From: "Davis, James T." <JTDAVIS@southernco.com>
To: "Christian Araguas" <CJA2@nrc.gov>
Date: 4/16/2007 6:08:12 PM
Subject: RAI Letter #6 Geology Response 2 of 3

RAI Figure 2.5.2-11, Liquefaction Sites for Events C, C, and D

AR-07-0801
Enclosure 1
RAI Response

RAI Figure 2.5.2-18A: Seismicity in southeastern US, showing earthquakes in the EPRI catalog (red dots) through 1984 and additional seismicity, 1985—mid April 2004 from the updated regional earthquake catalog.

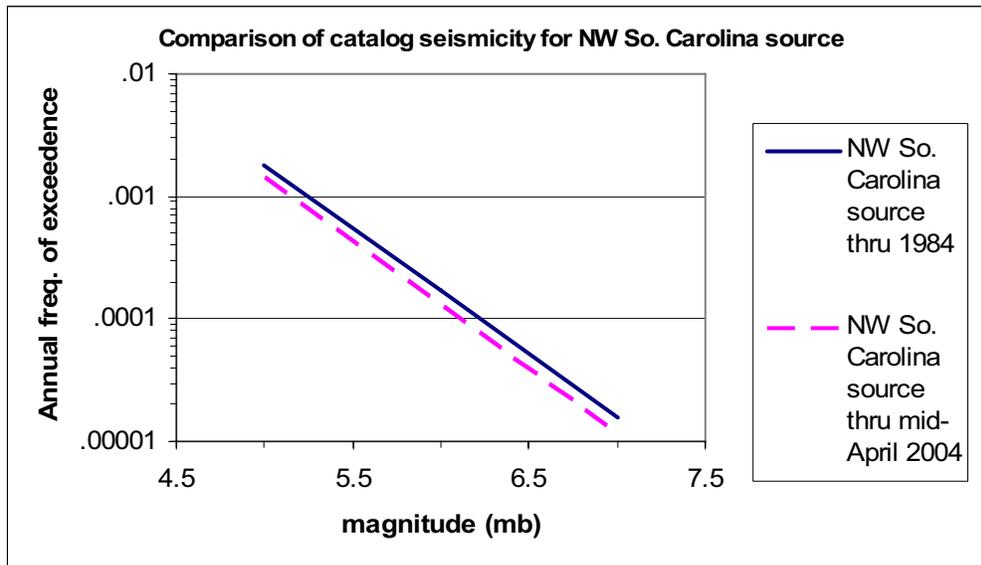
2.5.2-18 SSAR Section 2.5.2.4.2 describes the effects of the new regional earthquake catalog. Figure 2.5.2-16 shows the two areas used to examine the effect of the new seismicity information. Please provide a justification for the geometries of the two areas.

Several areas were used to examine the effect of the new regional earthquake catalog. RAI Figure 2.5.2-18A shows those regions. All four regions showed the same result, that additional seismicity from 1985 to mid-2004 does not increase estimated activity rate in the area around the Vogtle site. As an example, RAI Figure 2.5.2-18B shows the effect of additional seismicity in the square, northwest-South Carolina source shown in RAI Figure 2.5.2-18A. The estimated activity rate decreases, similar to what is shown in SSAR Figure 2.5.2-18. We conclude that any region in South Carolina that would affect the seismic hazard of Vogtle would have estimated activity rates stay constant or decrease, if the new regional earthquake catalog were added to the analysis.

RAI Figure 2.5.2-18B: Comparison of estimate activity rates for the square source in northwest South Carolina shown in RAI Figure 2.5.2-18A, for the original EPRI catalog and including the updated regional catalog.

SSAR Figure 2.5.2-21 Mean Uniform Hazard Spectra, Hard Rock Conditions, for VEGP ESP

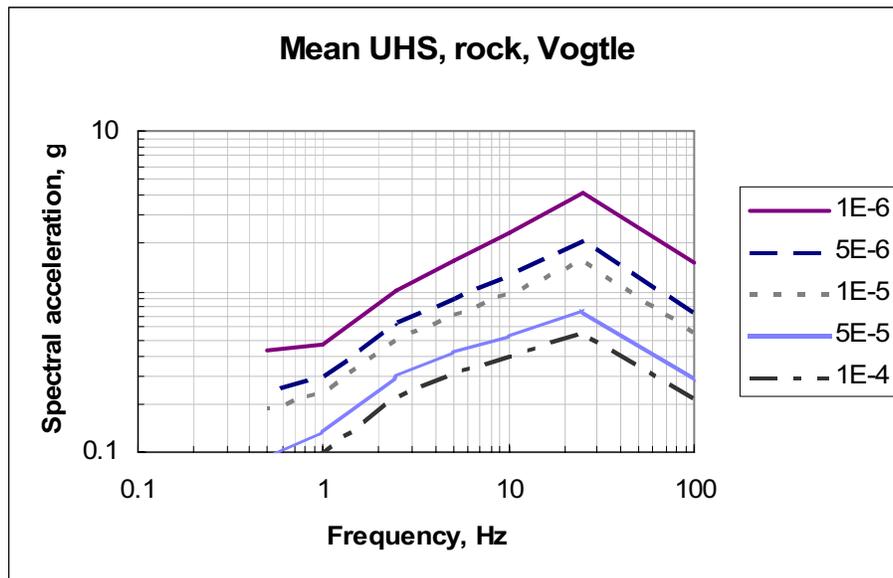
2.5.2-19 SSAR Section 2.5.2.5.1 describes the development of the site amplification functions and the soil uniform hazard response spectra (UHRS) for the 10-4 and 10-5 hazard levels. Please provide a detailed step-by-step discussion of the methodology used to develop the site amplification functions (i.e. Steps 1 to 6 in SSAR Section 2.5.2.5.1.1) and the 10-4 and 10-5 soil UHRS. If possible, please illustrate each step with relevant data.

STEP 1: PSHA is performed for hard rock conditions for 7 structural frequencies to calculate the 10^{-4} , 5×10^{-5} , 10^{-5} , 5×10^{-6} , and 10^{-6} rock uniform hazard spectral [UHS] ordinates at the 7 frequencies. Values are reported numerically in SSAR Table 2.5.2-16 and graphically in SSAR Figure 2.5.2-21, repeated here:

SSAR Figure 2.5.2-37 Typical Results of Spectral Amplification at 86-ft Depth (Top of Blue Bluff Marl) Using EPRI Degradation Curves for High Frequency Time Histories of 10^{-4} MAFE Input Motion Level

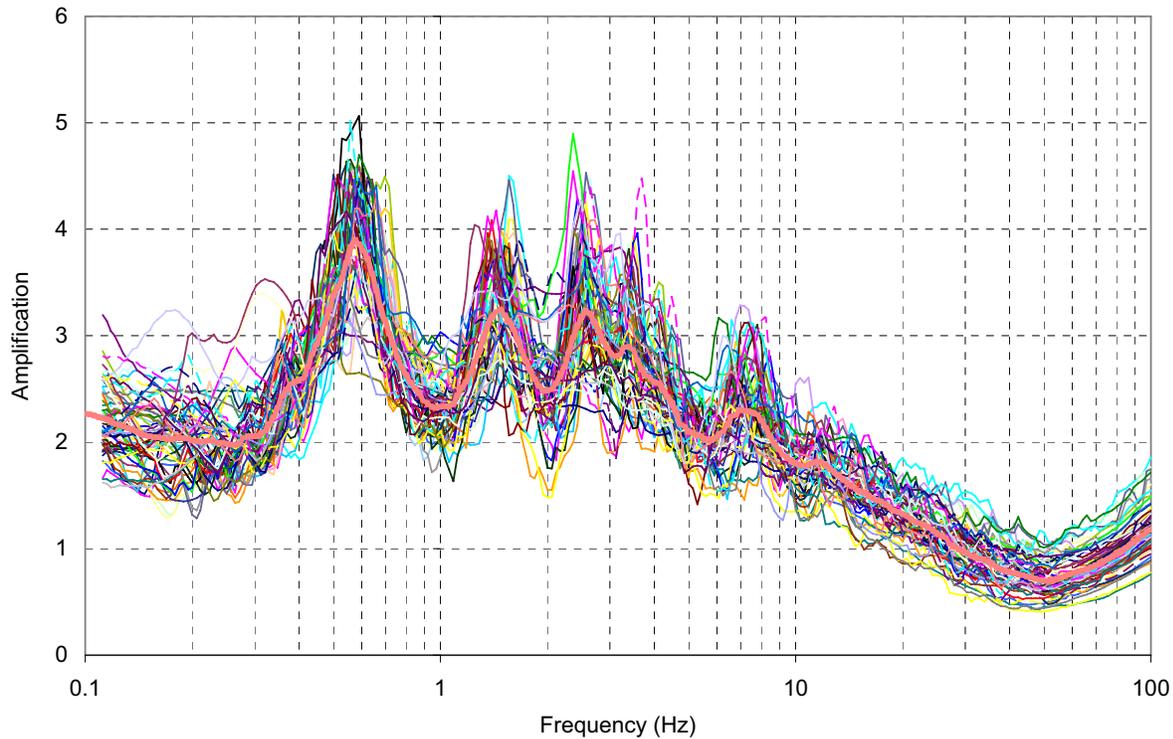
- a. In Step 5 of SSAR Section 2.5.2.5.1.1, what does the “envelope motion” refer to?
- b. In Step 6, please explain why either the high- or low-frequency mean amplification factor was used instead of their envelope?
- c. Step 6 states that “at some intermediate frequencies between 2 and 8 Hz, the high frequency (HF) and low frequency (LF) soil amplification factors (AF) are weighted in order to achieve a smooth transition between HF and LF spectra”. Please provide more information regarding this weighting procedure.

SSAR Figure 2.5.2-37, repeated below, illustrates the 60 individual AFs and the mean AF across the frequency range of 0.1 Hz to 100 Hz, for the 10^{-4} MAFE, HF input, EPRI mean material curves, and 86’ depth.

STEP 5B: The mean AFs for the EPRI and SRS material curves are equally weighted, to give 6 mean AFs across the frequency range 0.1 Hz to 100 Hz, for the control point horizon. These 6 mean AFs correspond to the 3 ground motion levels and to the HF and LF input motions.

STEP 5C: The controlling HF or LF input motion is determined over the frequency range 0.1 Hz to 100 Hz for each MAFE, by examining the envelope of soil response at the control point location (86' depth) due to the HF and LF rock motion. Note from Figure 2.5.2-35 (in the SSAR and above) that, at high frequencies, the HF rock input motion exceeds the LF rock input motion. At low frequencies, the reverse is true. This means that the HF input rock motion will control the high frequency soil responses (above 8 Hz) and the LF input rock motion will control the low frequency soil responses (below 2 Hz). In between, the controlling motion, which is the maximum soil response, depends on the MAFE and the frequency. This step results in one set of mean AFs (across the frequency range 0.1 Hz to 100 Hz) for each MAFE.

RAI Figure 2.5.2-21a Comparison between high-frequency spectral shapes using the recommended magnitude and distance values and the computed magnitude and distance values for the three annual probability levels of 1×10^{-4} , 1×10^{-5} , and 1×10^{-6} .

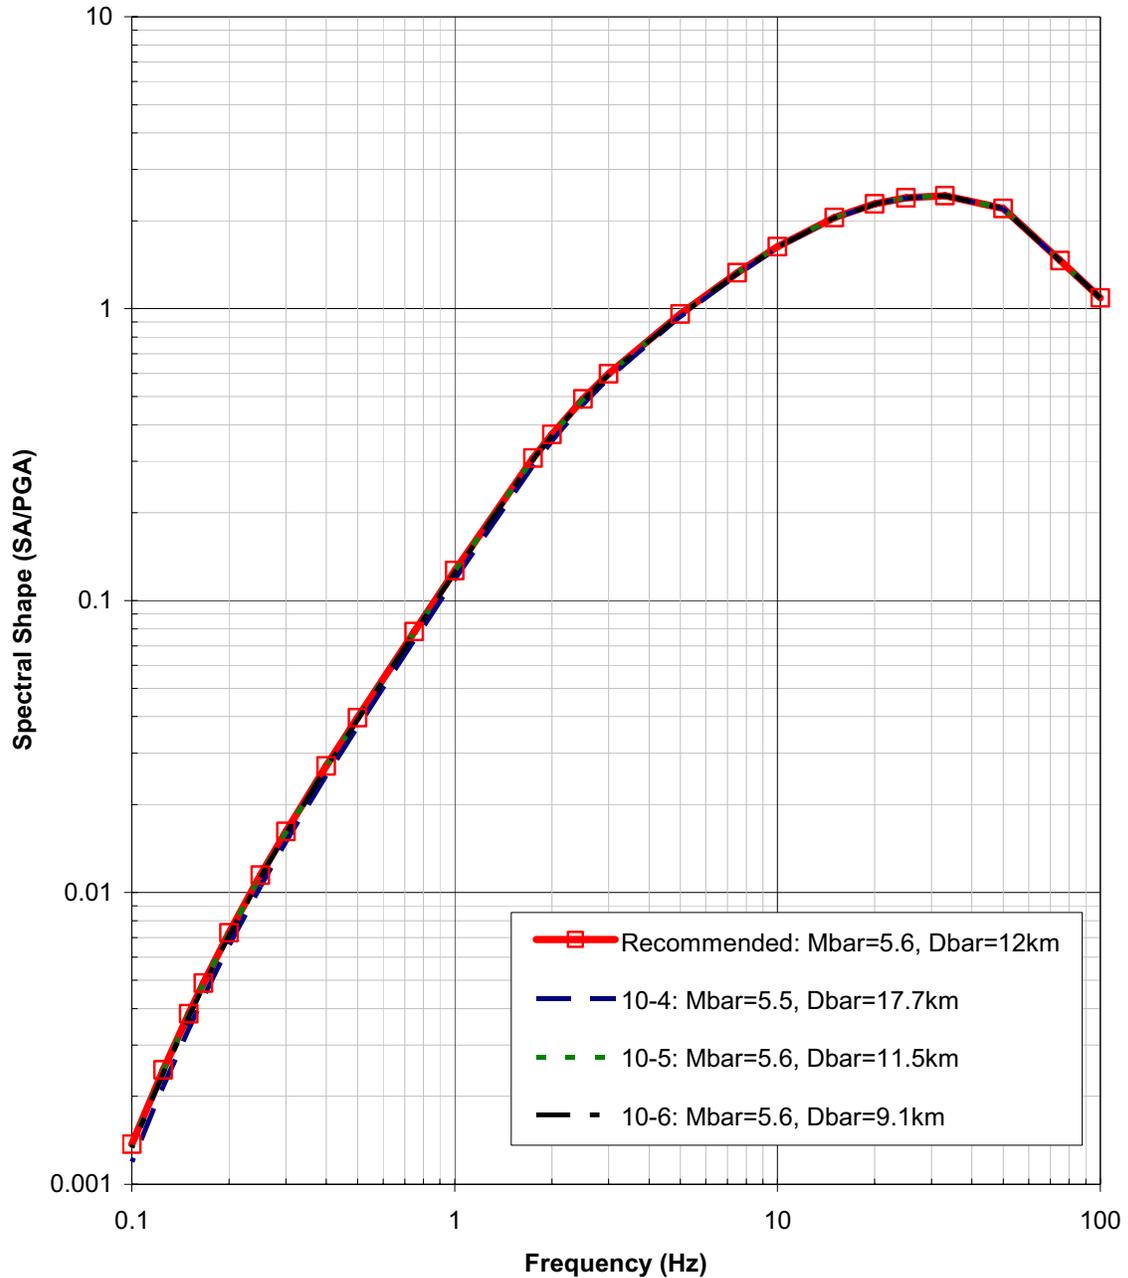
2.5.2-21 SSAR Table 2.5.2-17 and Section 2.5.2.5.1.3 provides the computed and recommended Mbar and Dbar values used for the development of the high- and low-frequency target response spectra. Please explain how the “recommended” Dbar and Mbar values were calculated.

Mean magnitude (Mbar) and distance (Dbar) values were computed for three annual probability levels: 1×10^{-4} , 1×10^{-5} , and 1×10^{-6} based on the seismic hazard curves for both the high- and low-frequency cases. Table 2.5.2-17 of the SSAR lists these values along with the recommended magnitude and distance values used in the analysis. These recommended values were selected such that they approximately represent the

range in Mbar and Dbar values computed for the three annual probability levels for both the high- and low-frequency cases based on the bi-modal distribution of the deaggregation. These recommended values were not computed based on a statistical average or otherwise from the explicit values for each of the three annual probability levels. For the low frequency case, the recommended distance value was assigned of distance of 130 km based on the source to site distance for the Charleston source. For the high frequency case, the recommended distance is approximately equal to the log-average of the three computed values rounded to the nearest km. The recommended magnitude values for both the high- and low-frequency cases is equal to the linear average of the three magnitude values rounded to the nearest tenth of a magnitude unit.

These recommended Mbar and Dbar values were used to simplify the analysis, rather than the computed values at the three annual probability levels, for the development of the corresponding target spectra and to a lesser extent in the time history selection procedure for the site response analysis. RAI Figure 2.5.2-21a shows the difference in spectral shapes for the high-frequency case using the recommended magnitude and distance values and the computed magnitude and distance values for the three annual probability levels. The same comparison is presented in RAI Figure 2.5.21b for the low-frequency case. Based on these comparison plots, the use of the recommended magnitude and distance values in place of the computed magnitude and distance values for each of the three annual probability levels would not significantly change the results of the site response analysis.

RAI Figure 2.5.2-23A. ESP Base Profiles – 5% Damping ARS Amplifications at 86 ft Depth

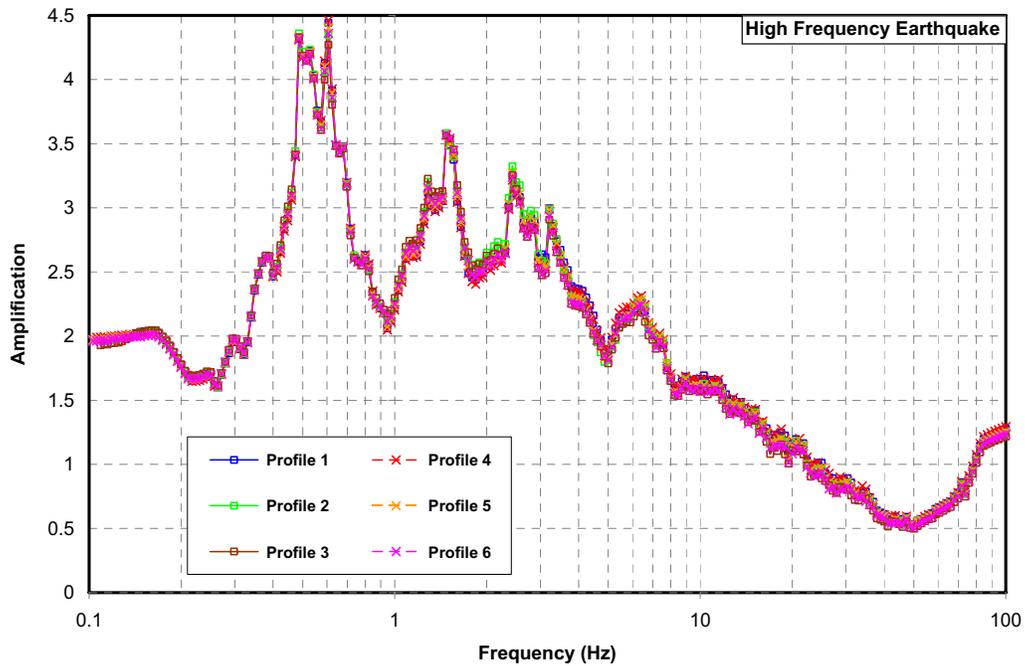
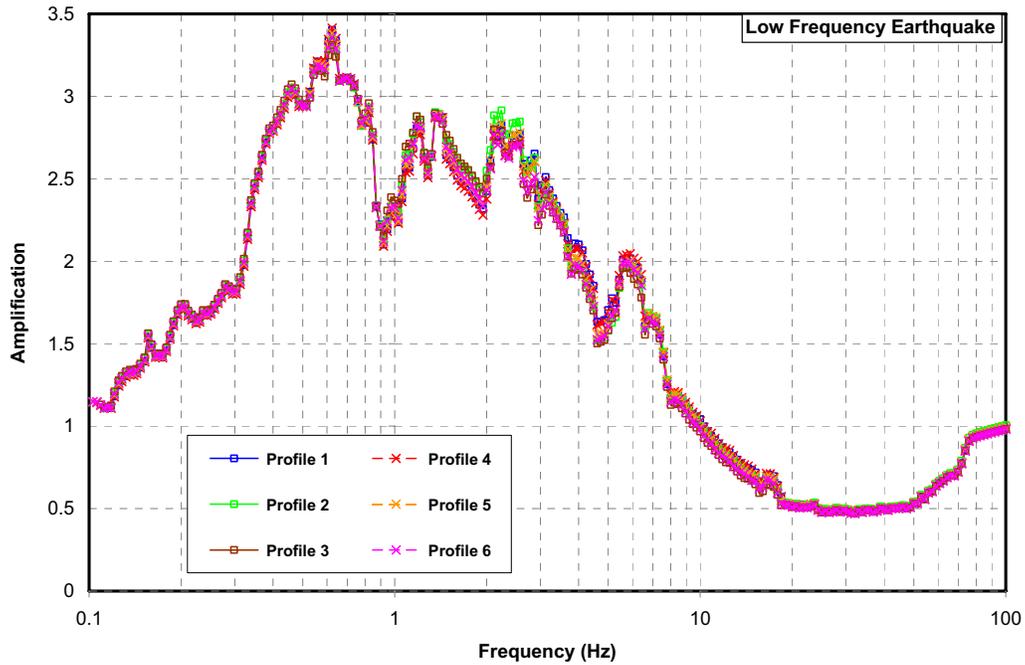
- a. The effects of the six alternative site response profiles in terms of the different depths to the top of the Paleozoic crystalline rocks.**
- b. The possible effects of the Pen Branch fault zone (i.e. as a low velocity zone or weak zone).**
- c. The effects of the low velocity zones within the Blue Bluff Marl and Lower Sand Stratum.**

Two acceleration time histories were developed compatible with the high frequency (HF) (5-10 Hz) and low frequency (LF) (1-2.5Hz) target spectra at 1×10^{-5} probability level. SHAKE analyses were performed where the acceleration time histories were applied as outcrop object motion at the top of the crystalline bedrock. RAI Figure 2.5.2-23A compares the results of the SHAKE analyses of the six base profiles for the 5% damping acceleration response spectra (ARS) amplifications at the top of the Blue Marl at 86 ft depth. The small difference in the ARS amplifications indicate that the effect of the depth of the crystalline rock on the site response at 86 ft depth horizon where the SSE design motion is defined is relatively small, particularly in comparison to the variability of total [soil and rock] site response when soil/rock column model randomization and multiple time histories are considered (see SSAR Figure 2.5.2-37).

RAI Figure 2.5.3-2A Photo Mosaic and Geologic Interpretation of a Portion Trench, West Wall

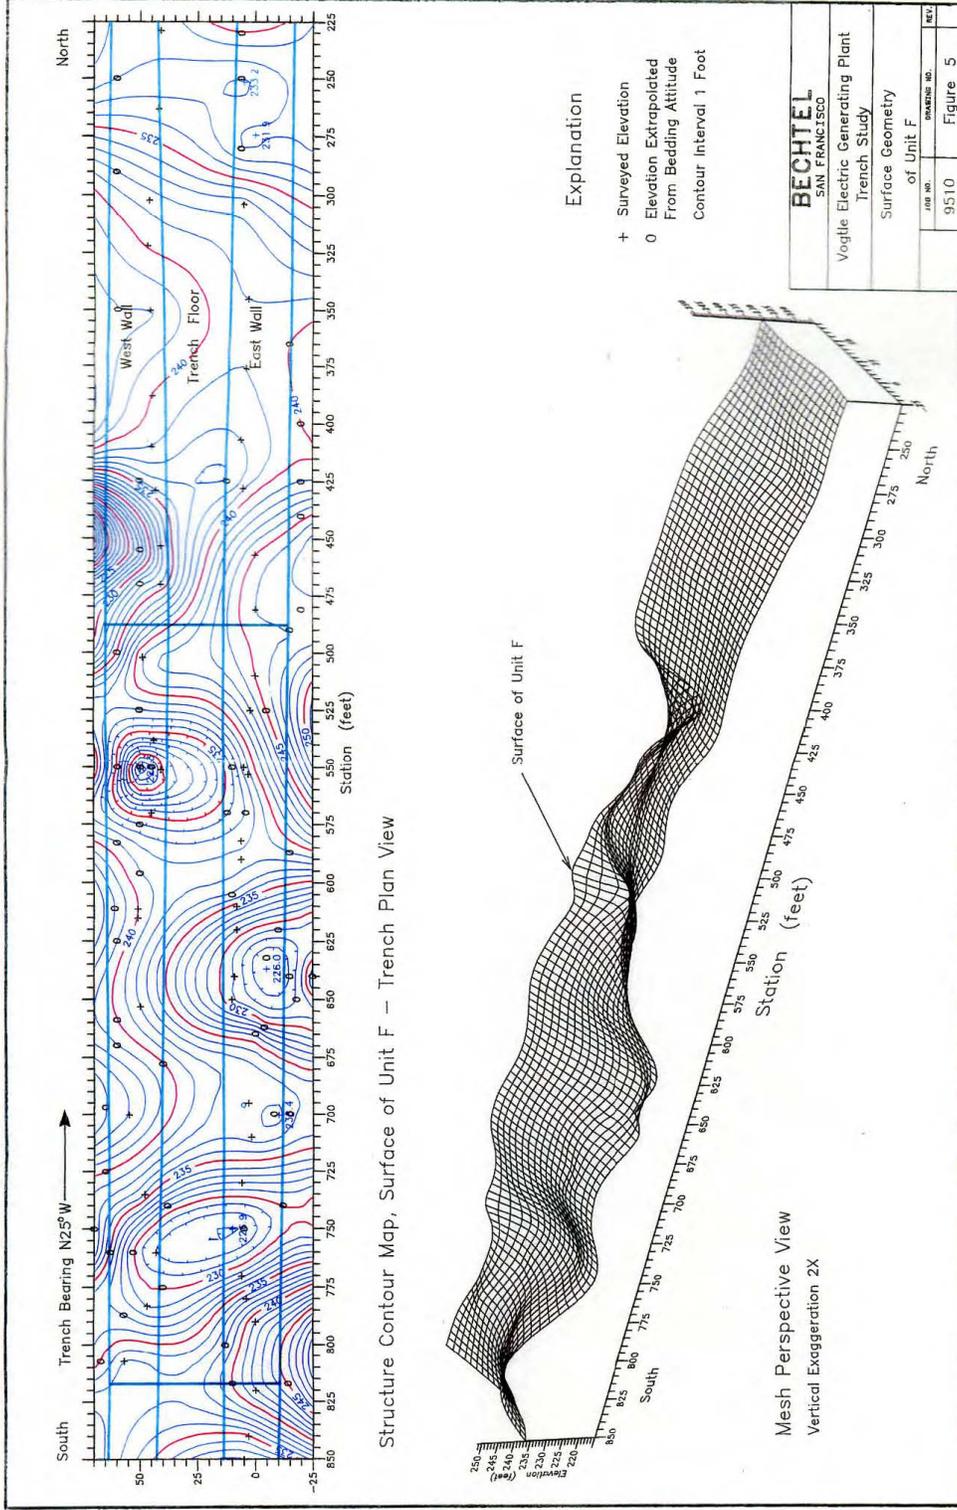
b. Please discuss field data, observations, and reasoning which resulted in the conclusion about a dissolution origin for the warped bedding, fractures, small-scale faults, and injected sand dikes, including a specific explanation of the formation mechanism for the injected dikes.

The dissolution origin for the warped bedding, fractures, small-scale faults, “clastic dikes” and sand-injected dikes is interpreted largely from the observations and detailed documentation of these features in a large trench exposure that was over 900 ft long, 30 to 45 ft deep, and 25 to 40 ft across (Bechtel 1984). The high concentration of these features within the trench and the spatial and kinematic relationships between different types of deformation features provide some of the best information regarding their origin (see RAI Figure 2.5.3-2A). Field mapping efforts performed as part of the VEGP ESP application also identified “clastic dikes” within the VEGP site and surrounding site area, and similarly concluded these features are of a non-tectonic origin based on field observations.

The 3-dimensional nature of the warped bedding, combined with the spatial and kinematic relationships of the small-scale faults and fractures along the margins of the more strongly warped depressions, clearly demonstrates a dissolution or sediment collapse origin. The highly irregular, discontinuous nature of folding is consistent with a non-tectonic dissolution origin and inconsistent with a tectonic origin, since there are no laterally persistent fold axes (see RAI Figure 2.5.3-2B following this response). If this minor fold deformation was associated with the underlying Pen Branch fault, fold axes should be laterally persistent and parallel to the fault. The discontinuous nature of domes and depressions in an “egg carton” or “dimpled” pattern reflects the more random, non-tectonic process of dissolution. The concentration of fractures and small normal faults at the margins of the structural lows (Sta 450 in RAI Figure 2.5.3-2A following this response) illustrates that the minor folding is a result of dissolution collapse in underlying strata, as opposed to localized, differential uplift of the domes.
